#### AMENDMENTS KEY:

| 1   | 20/07/20 | Issued to show EWA changes | SR | 145     |

1 SITE-East Elevation - SH & WS  
1:125

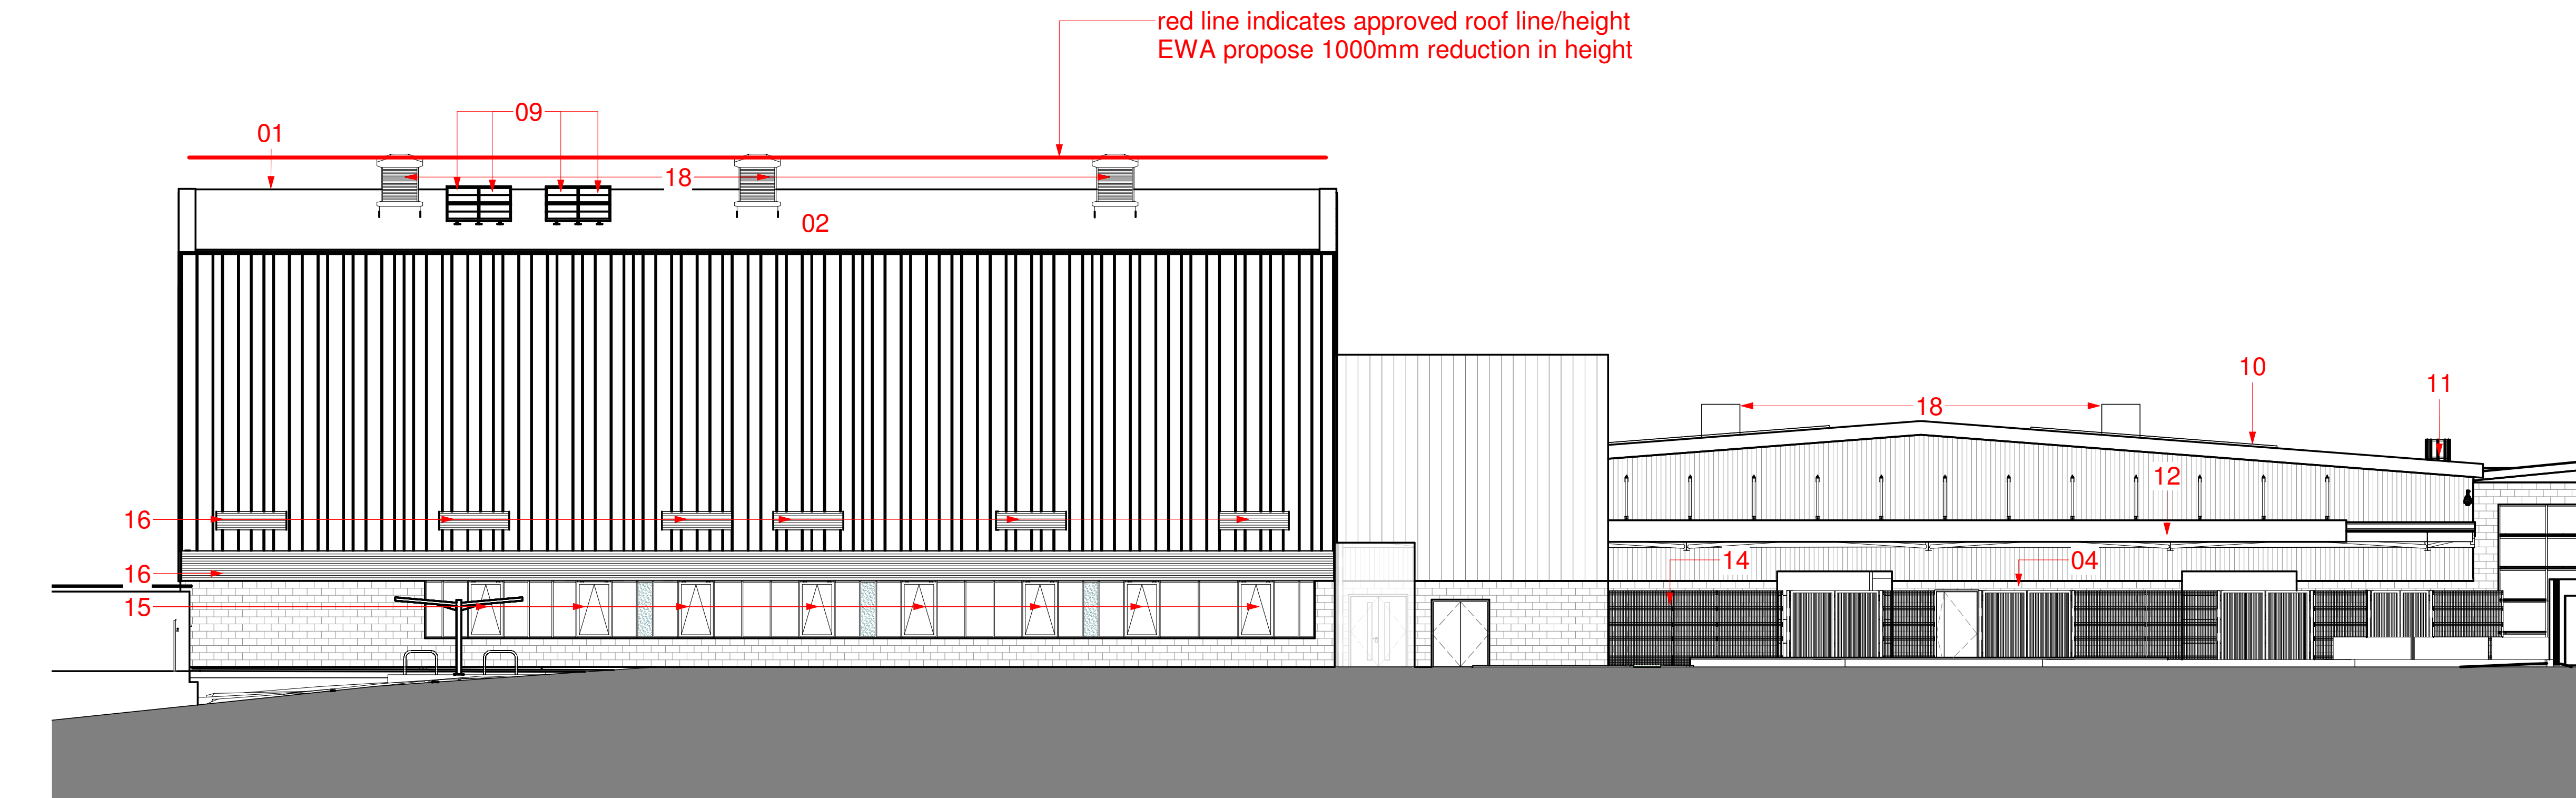
- 01 - A 1000mm Reduction in Building Height to sports hall
- 02 - Omission of Sports hall rooflights
- 03 - Blockwork introduced – reduction of Kalzip
- 04 - Blockwork plinth to the compound

- 05 - Addition of Access hatch and roof access system
- 06 - North Façade change from Render to equitone boards and stone panelling
- 07 - Change of polycarbonate to opaque glazing

- 08 - Omission of access from plant room to workshop roof
- 09 - PV units added
- 10 - Reduction to Rooflights to Workshop
- 11 - Access ladders to Workshop Roof

- 12 - Canopy as cantilever instead of posted
- 13 - Re configuration of Stepped Terrace levels
- 14 - Increase of compound area to abut the staircase walling

- 15 - Purge vents into the linear windows
- 16 - QED louvres to façade
- 17 - Reduced size of louvres to East & West Elevations
- 18 - Added Ventilation chimneys to sports hall roof

- 19 - Introduction of mullion to picture window
